EXISTING TECHNICAL SPECIFICATIONS AND BASES  
UNIT 2

PROPOSED TECHNICAL SPECIFICATIONS AND BASES  
UNIT 2

TECHNICAL SPECIFICATION PAGES CONTAINING THE CHANGES WHICH WERE PREVIOUSLY  
REQUESTED IN AMENDMENT APPLICATION NO. 117 (PCN-354) DATED SEPTEMBER 3, 1992,  
AND ARE BEING REQUESTED IN THIS LICENSE AMENDMENT  
APPLICATION NO. 118 (PCN-335)

FIGURE 3.4-2

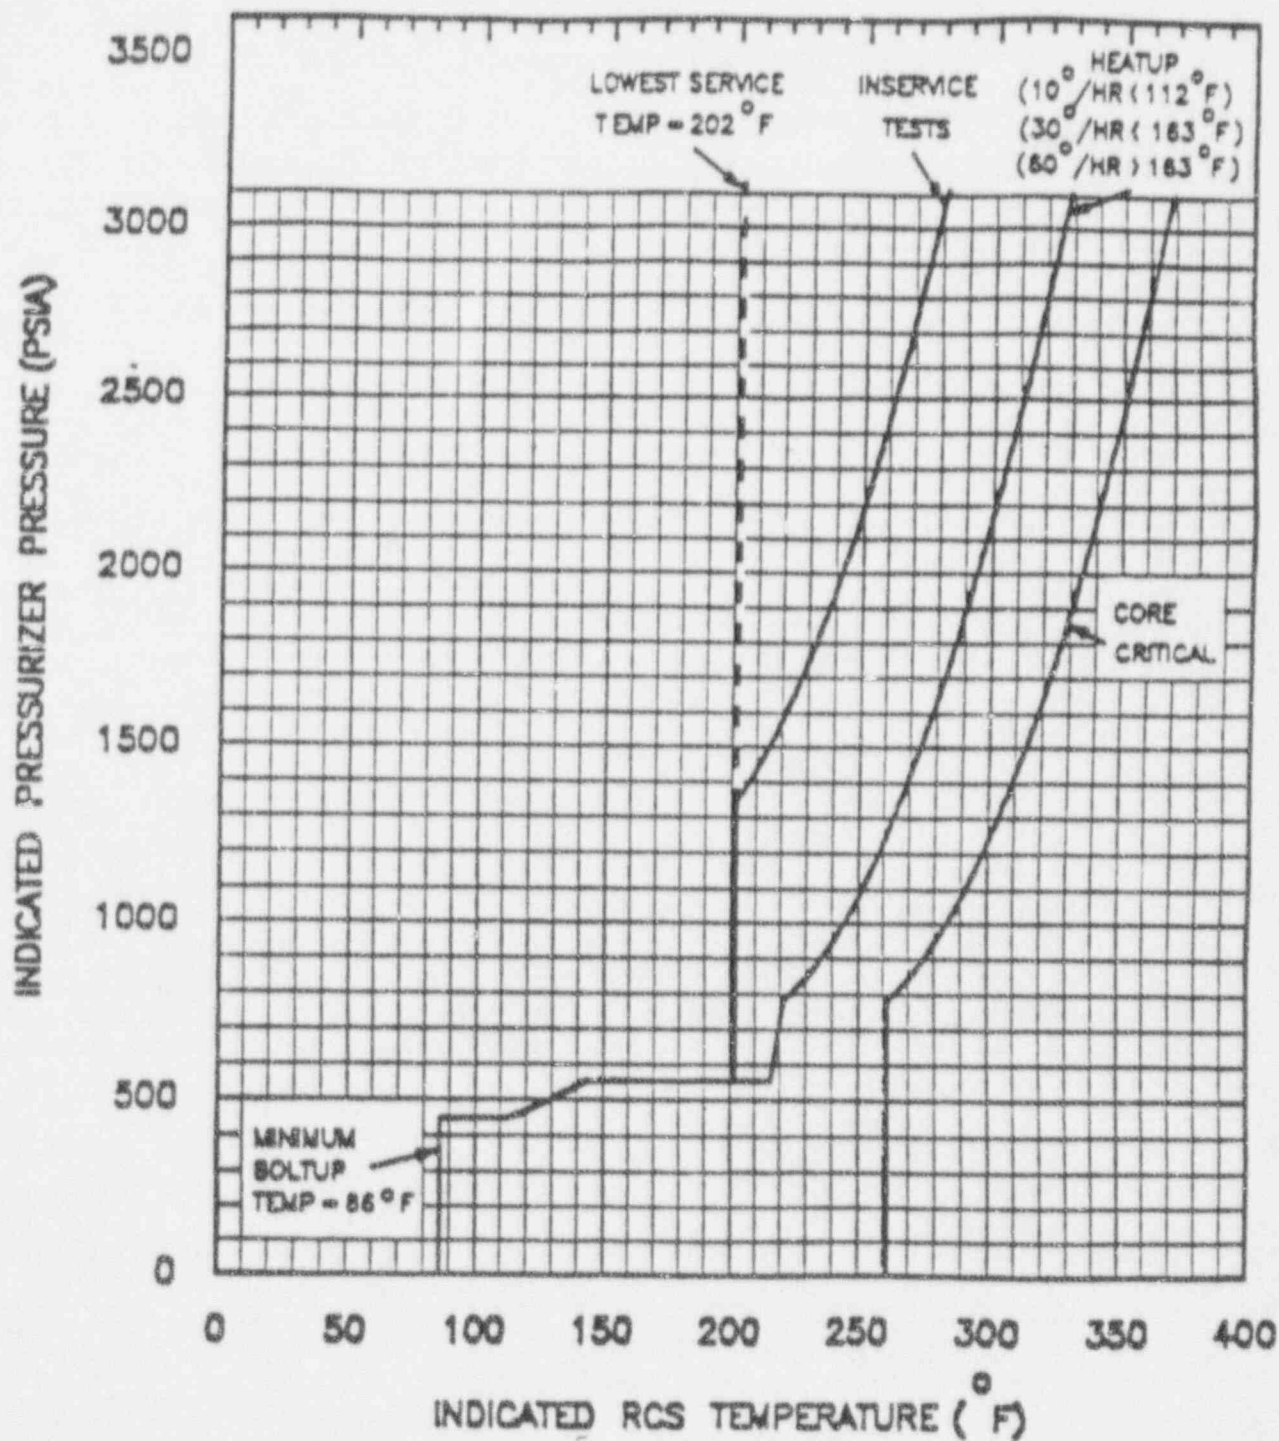
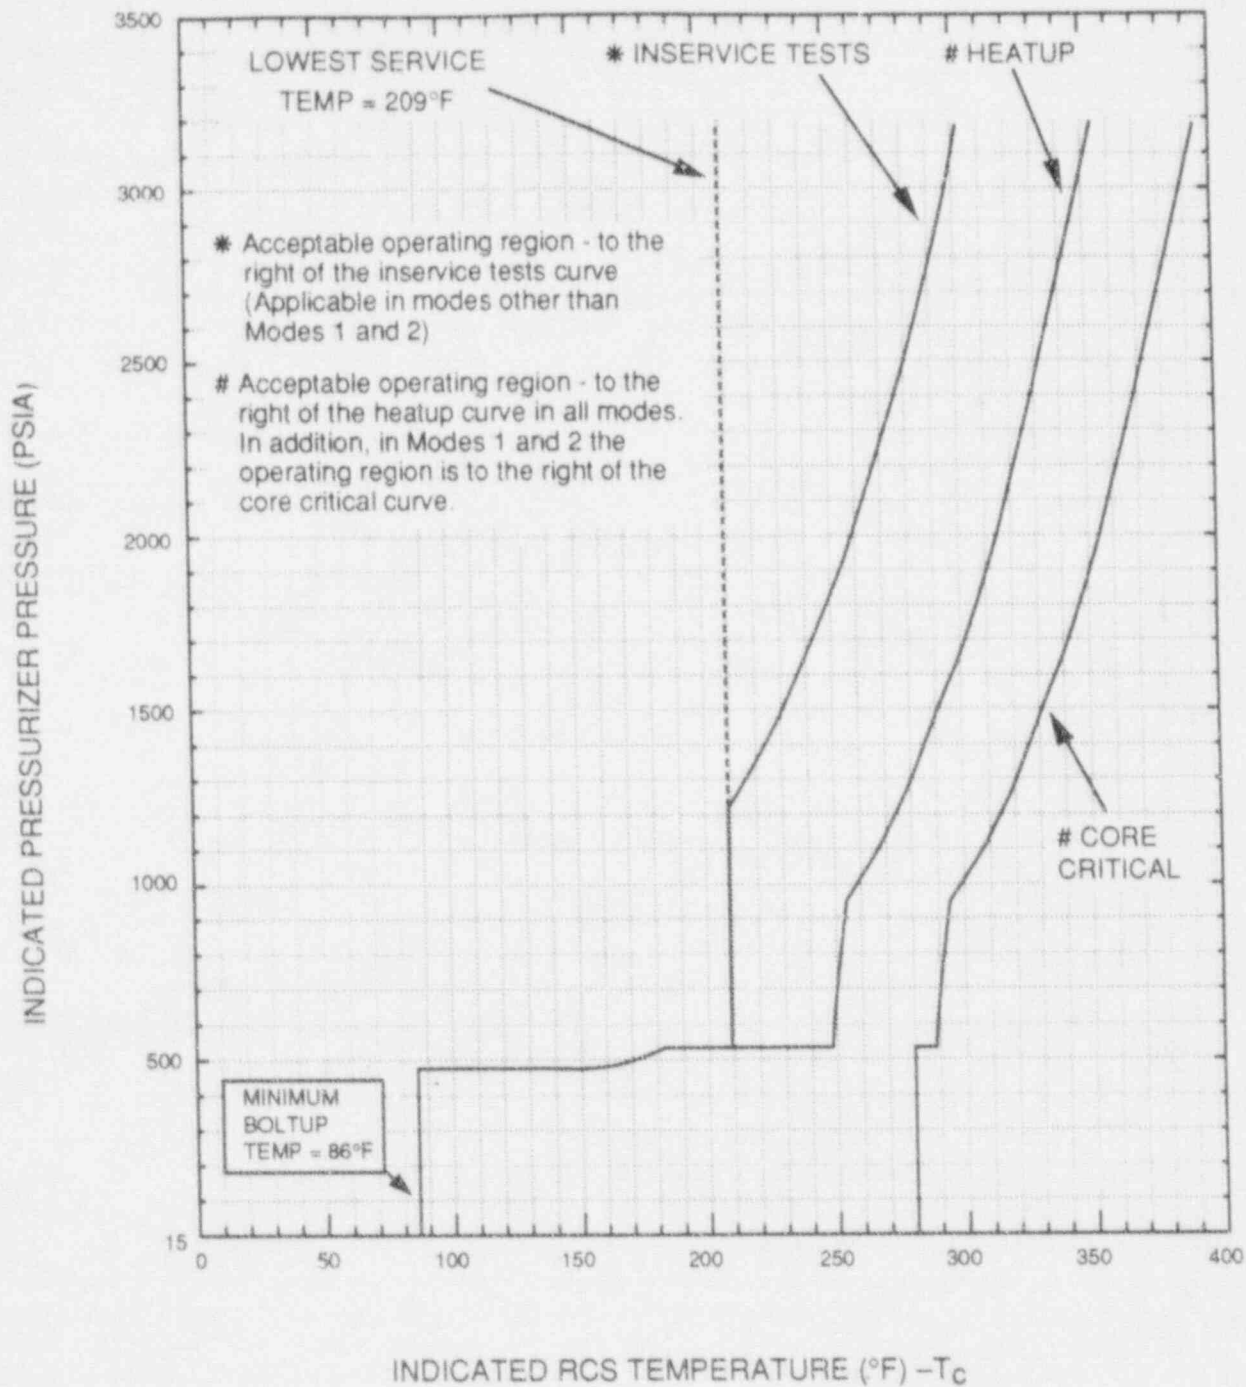
3.4.8.1 With the reactor vessel head bolts tensioned\*, the Reactor Coolant System (except the pressurizer) temperature and pressure shall be limited in accordance with the limit lines shown on Figures 3.4-2, and Figure 3.4-24, 3.4-5, 3.4-6, and 3.4-7 during heatup, cooldown, criticality, boltup, and inservice leak and hydrostatic testing with:

The heatup and cooldown limit curves for normal operation (Figures 3.4-2 and 3.4-3 3.4-4) and the cooldown limit curve for remote shutdown operation (Figure 3.4-6) are composite curves which were prepared by determining the most conservative case, with either the inside or outside wall controlling, for any heatup rate of up to 60°F/hr or cooldown rate of up to 100°F/hr. The limit curves for Remote Shutdown operation are determined using the Total Loop Uncertainties (TLUs) for temperature and pressure for the Remote Shutdown Panel instruments in which the pressure TLUs are higher than those for the Control Room shutdown instruments. The heatup and cooldown curves were prepared based upon the most limiting value of the predicted adjusted reference temperature at the end of the service period, and they include adjustments for possible errors in the pressure and temperature sensing instruments instrument uncertainties, and static and dynamic heads.

SONGS 2 HEATUP RCS PRESSURE/TEMPERATURE  
LIMITATIONS FOR 4-8 UNTIL 20 EFY  
Normal Operation

FIGURE 3.4-3 3.4-4  
 SONGS 2 COOLDOWN RCS PRESSURE/TEMPERATURE  
 LIMITATIONS FOR 4-8 UNTIL 20 EFY  
 Normal Operation

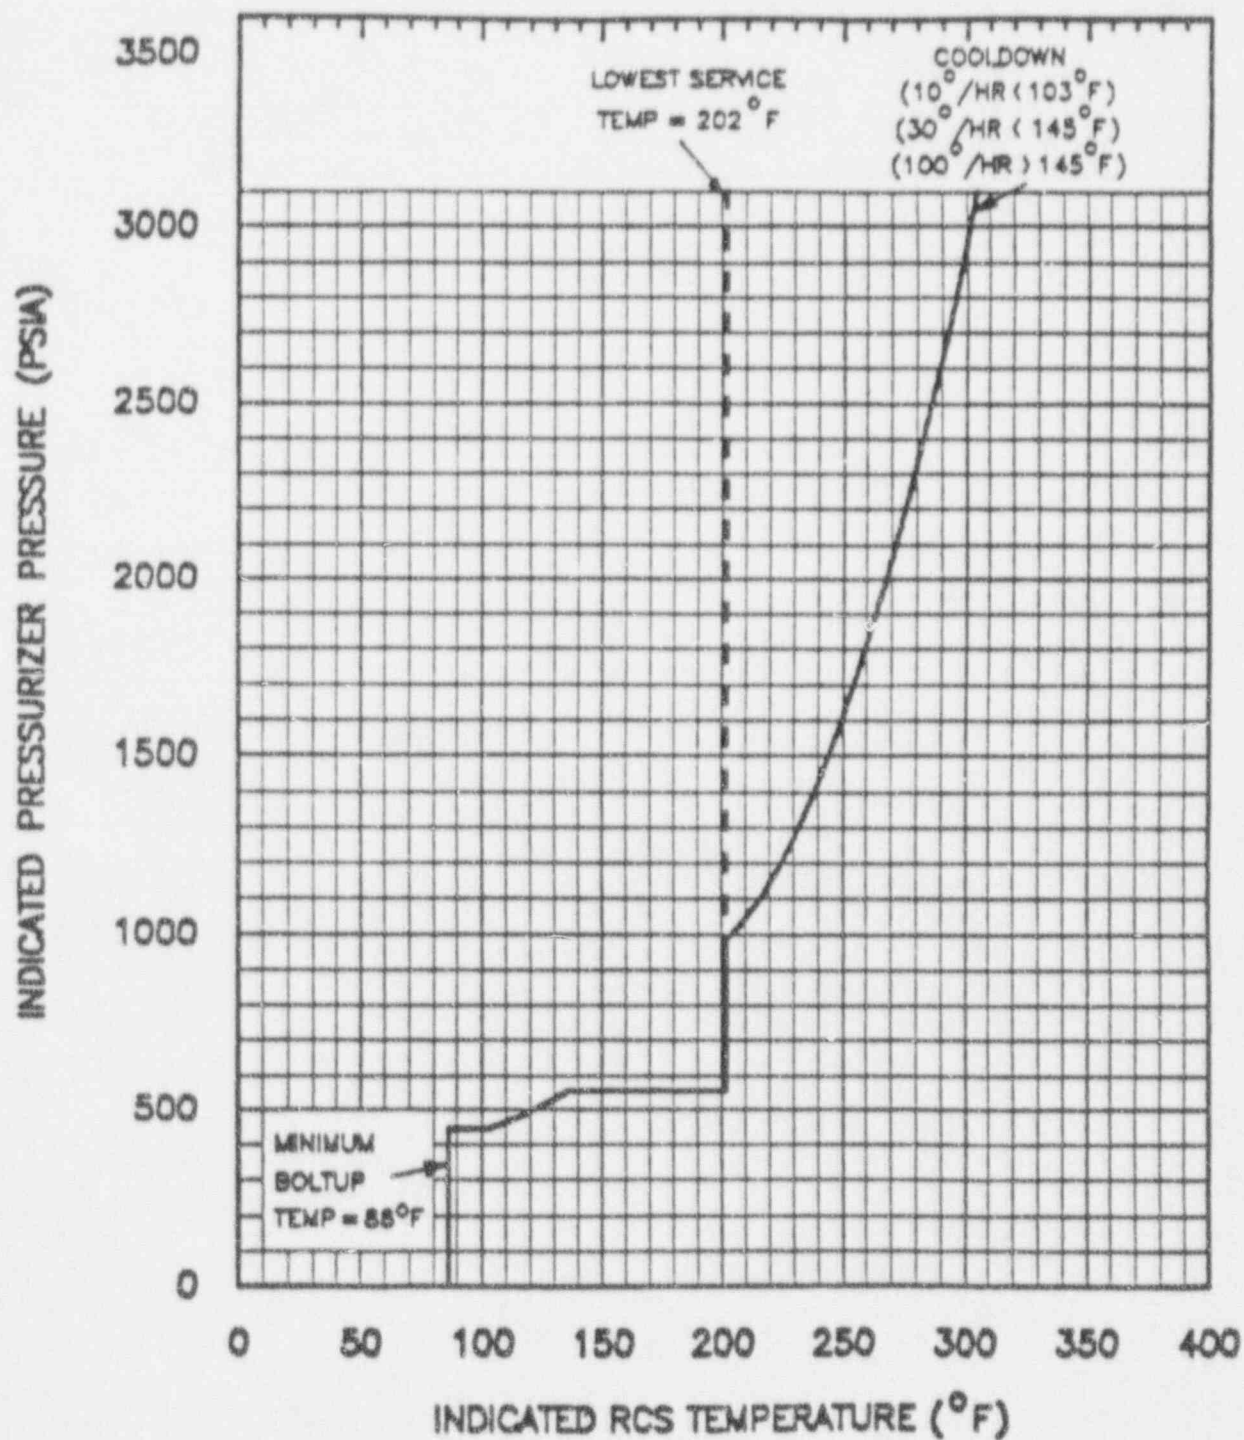
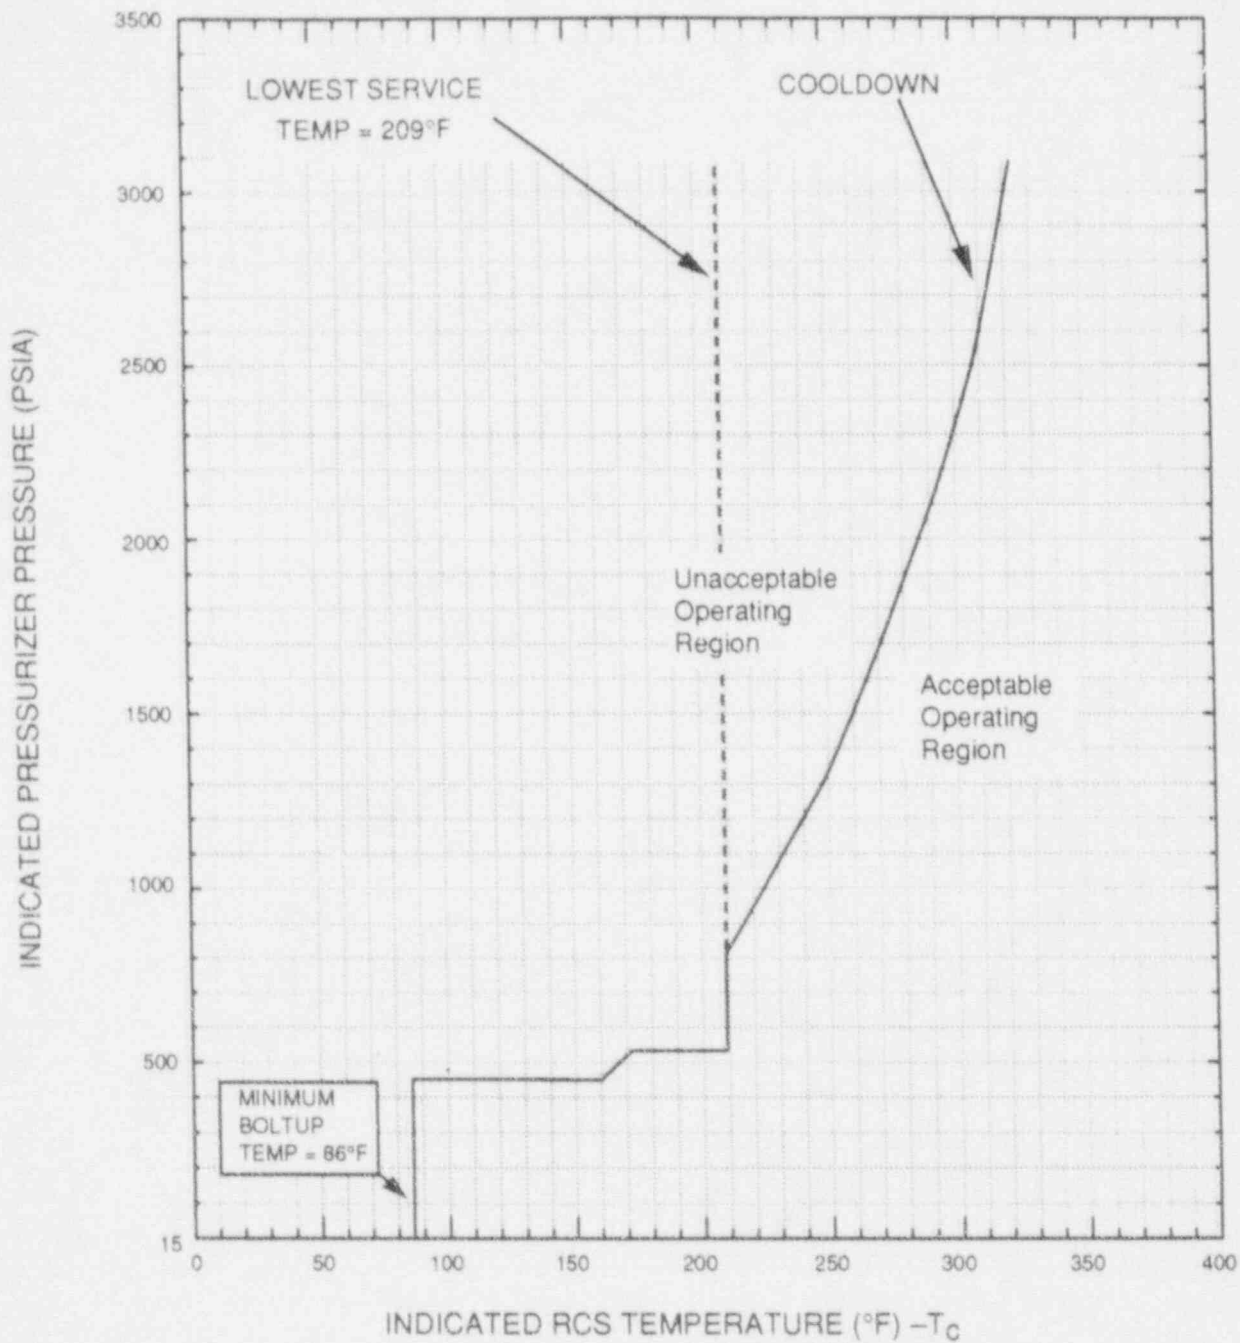
(Figure 3.4-3 - Not Used)

FIGURE 3.4-5

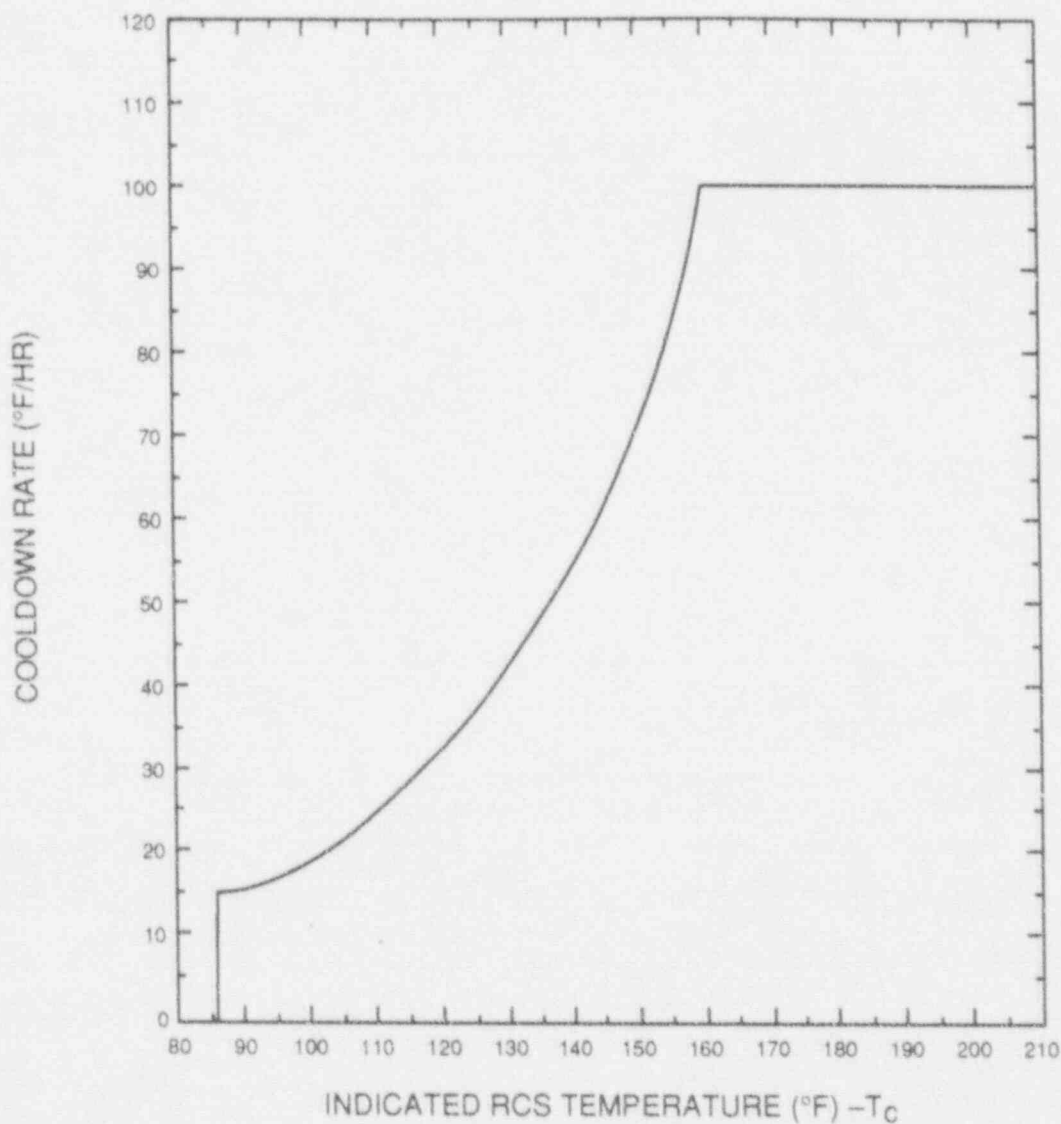
- b. ~~A maximum cooldown of 10°F in any one hour period with RC cold leg temperatures less than 103°F. A maximum cooldown of 30°F as specified by Figure 3.4-5 in any one 1-hour period with RCS cold leg temperatures less than or equal to 145 160°F. A maximum cooldown of 100°F in any one 1-hour period with RCS cold leg temperature greater than 145 160°F.~~ Sup 1

NOTE: A MAXIMUM COOLDOWN RATE OF 100°F/HR IS ALLOWED  
AT ANY TEMPERATURE ABOVE 160°F

FIGURE 3.4-7

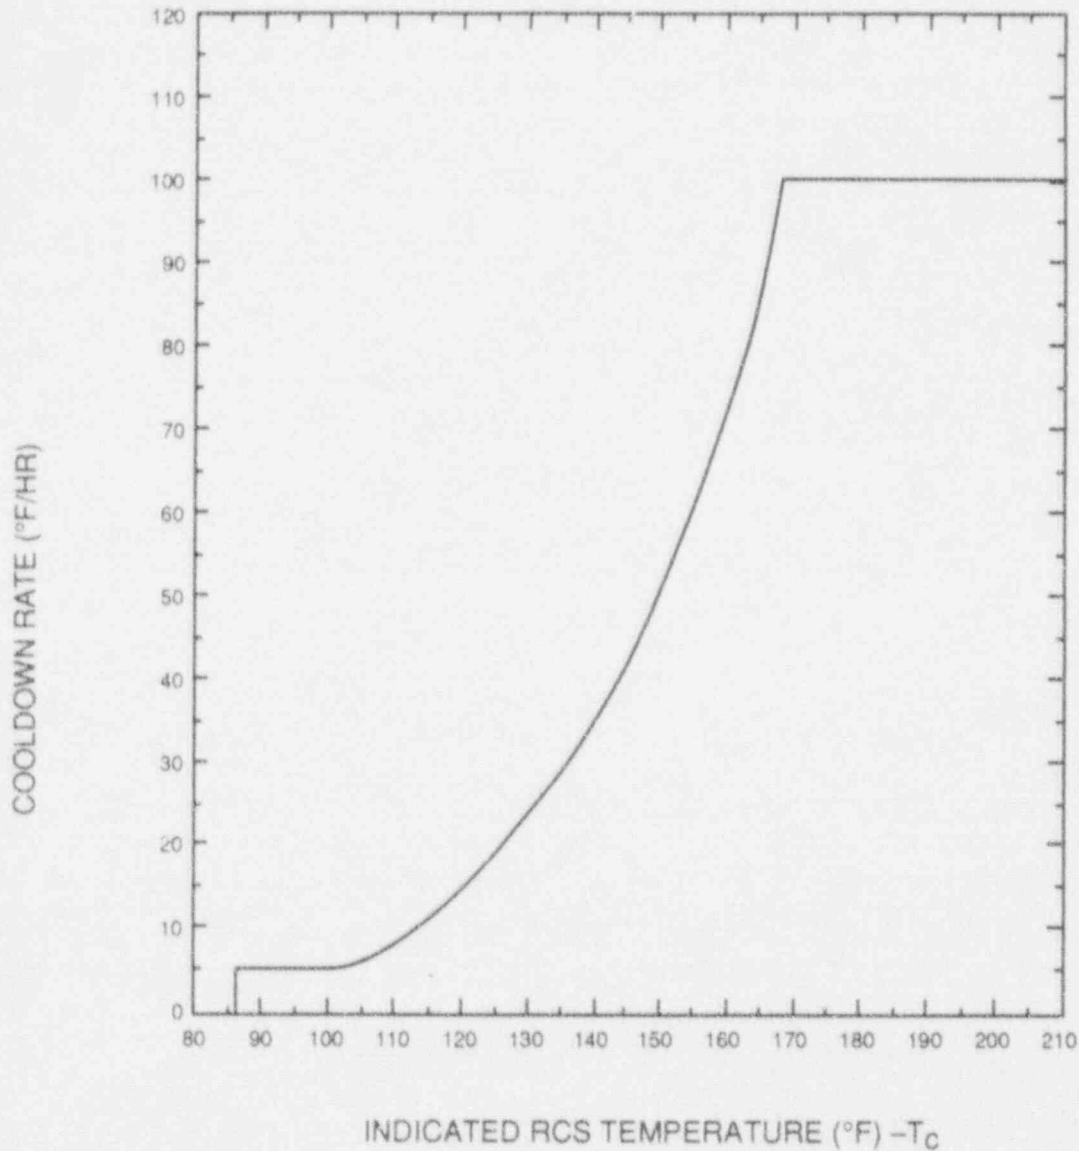
NOTE: A MAXIMUM COOLDOWN RATE OF 100°F/HR IS ALLOWED  
AT ANY TEMPERATURE ABOVE 168°F
